Talbott Springs Elementary School Replacement
Howard County Public School System

To: All Plan Holders
Project: Talbott Springs Elementary School Replacement
Columbia, Maryland
Re: Addendum #4

Addendum No. 4

New Talbott Springs Elementary School

4 SLOPED CONCRETE CURB DETAIL
A-421 SCALE: 1/2" = 1'-0"

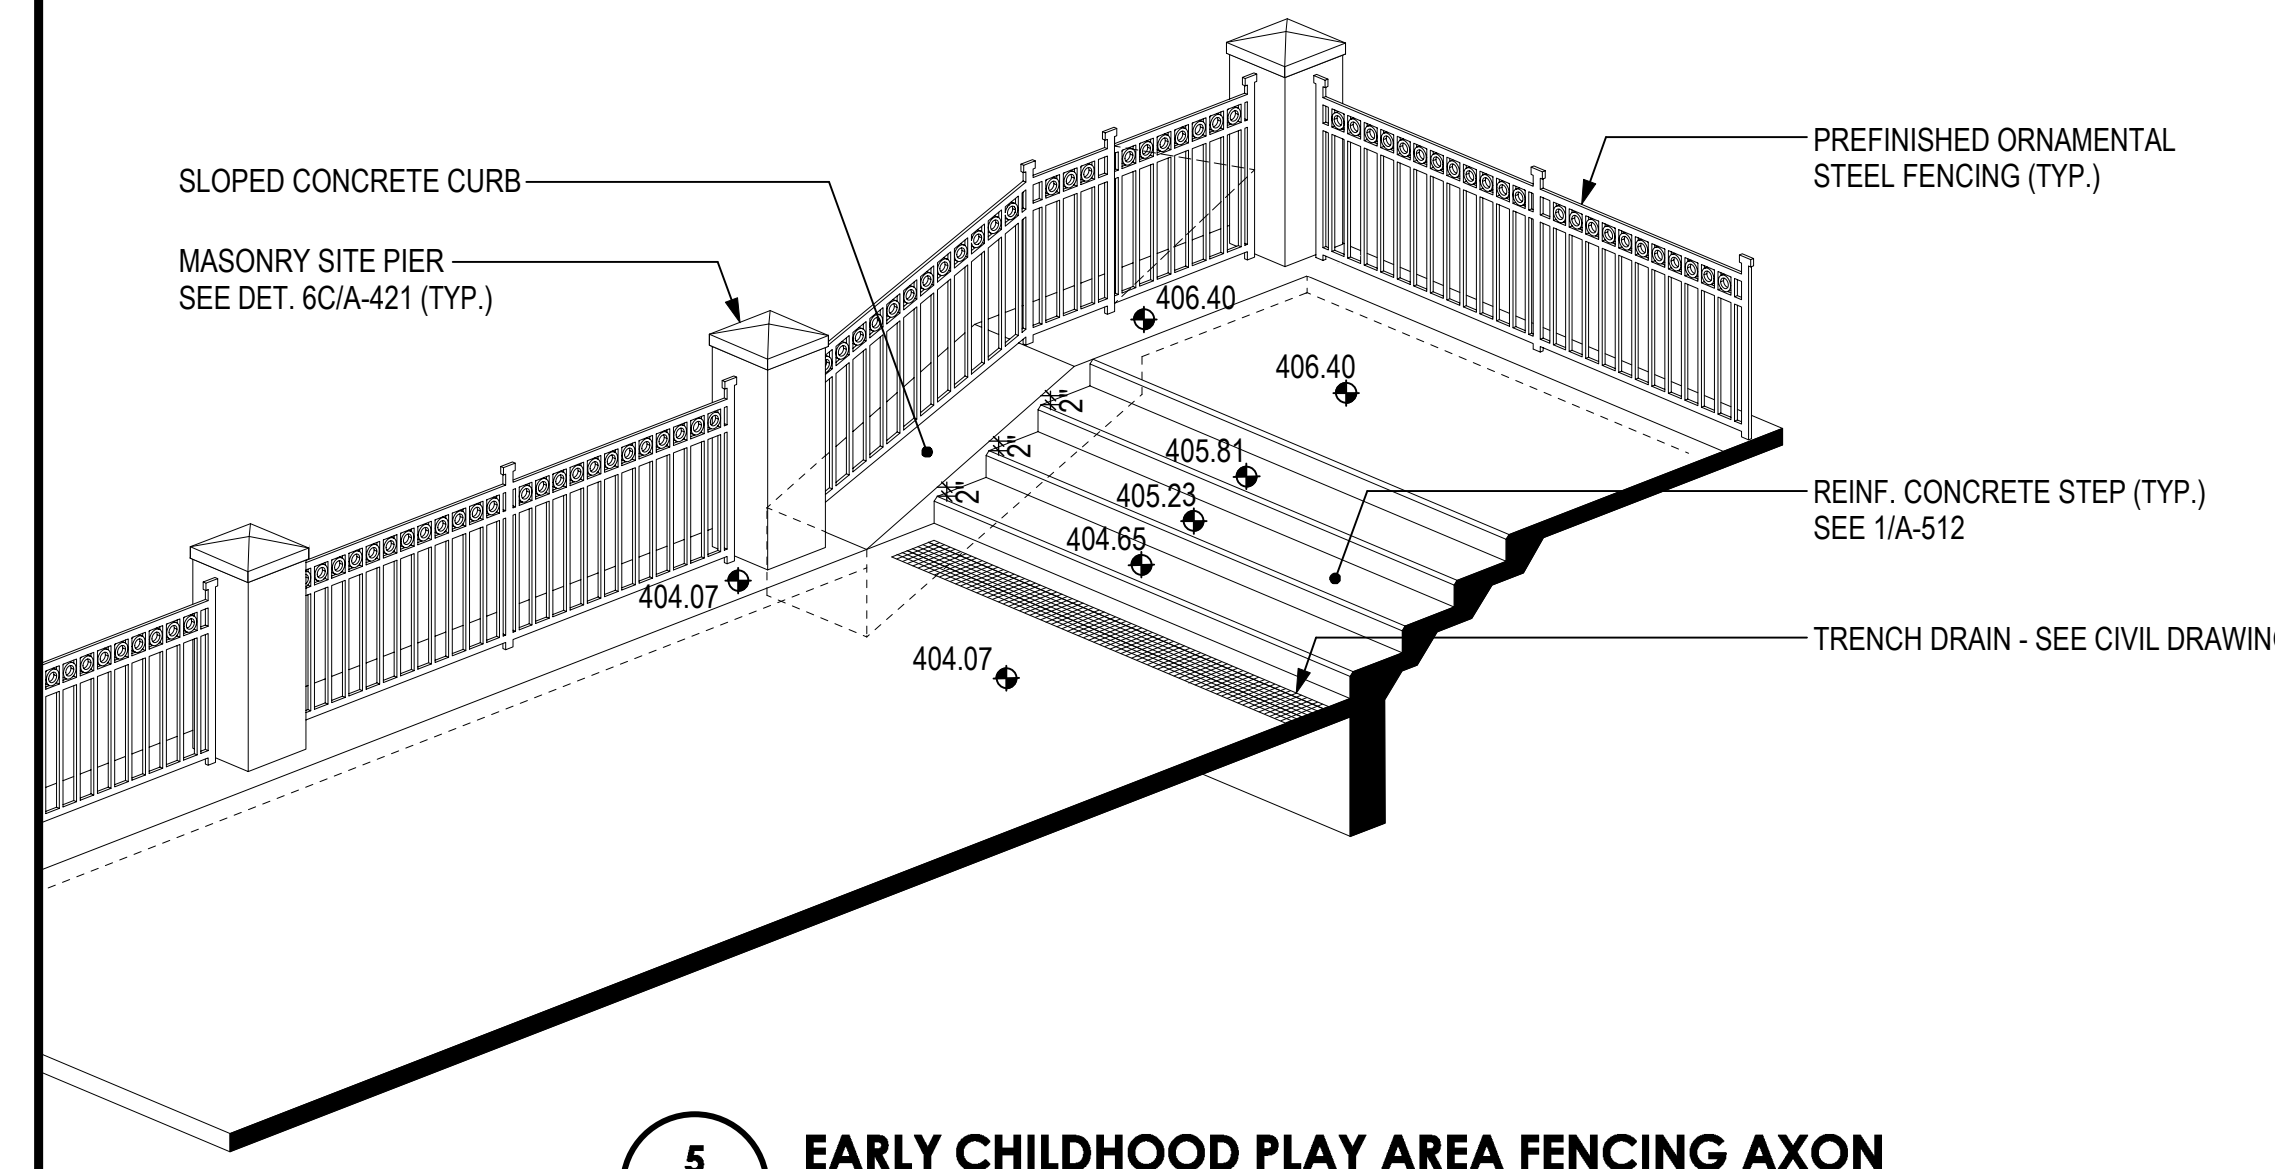
ADD Detail 4/A-421 SLOPED CONCRETE CURB DETAIL and 5/A-421 EARLY CHILDHOOD PLAY AREA AXON.

4 METAL ROOF RAKE DETAIL 3"

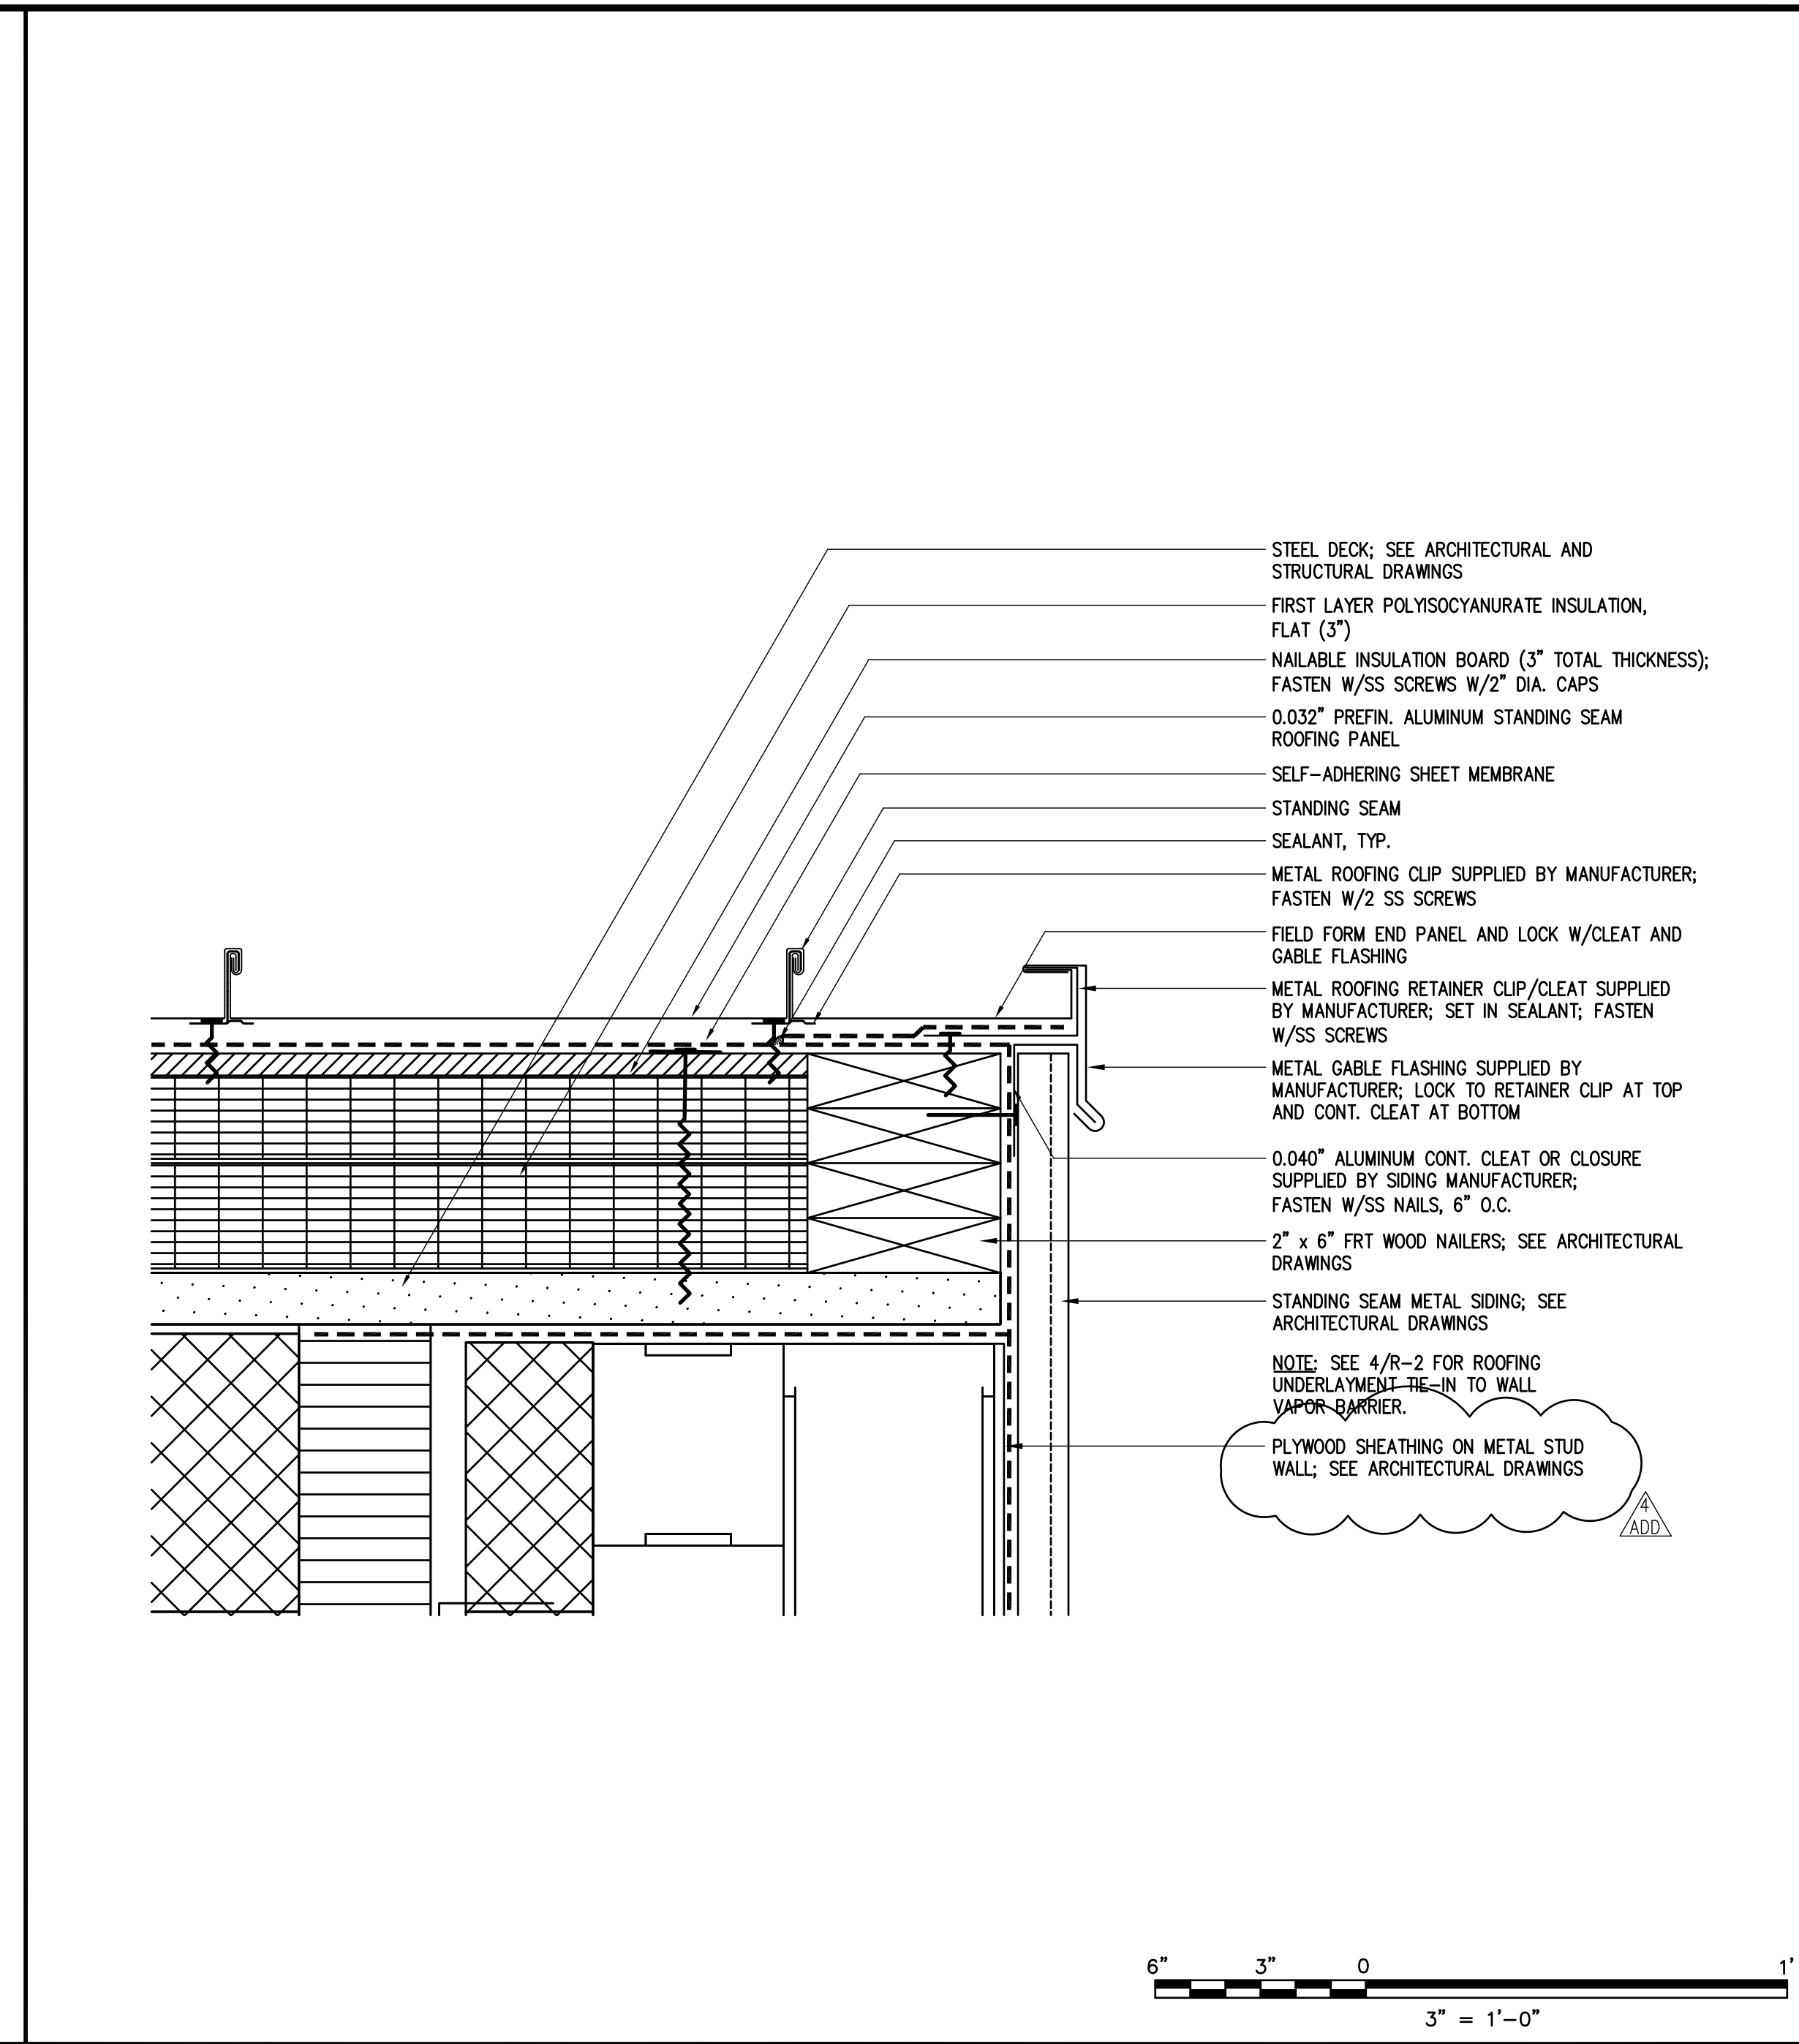
REVISE Detail 4/R-4 METAL ROOF RAKE DETAIL to show plywood sheathing and self-adhering underlayment between metal wall panels and metal wall framing.

Details 2/A-512, 2/A-514 and 4/R-4 indicates siding panels attached directly to vertical stud framing. This detail is not plausible, vertical standing seam siding panels cannot be attached directly to vertical stud framing. Furthermore, details 6 and 7/A-511 show aluminum standing seam siding attached to plywood at the metal studs.

Install metal siding panels over plywood on metal framing. Cover plywood with self-adhering sheet underlayment. Detail 4/R-4 has been updated.
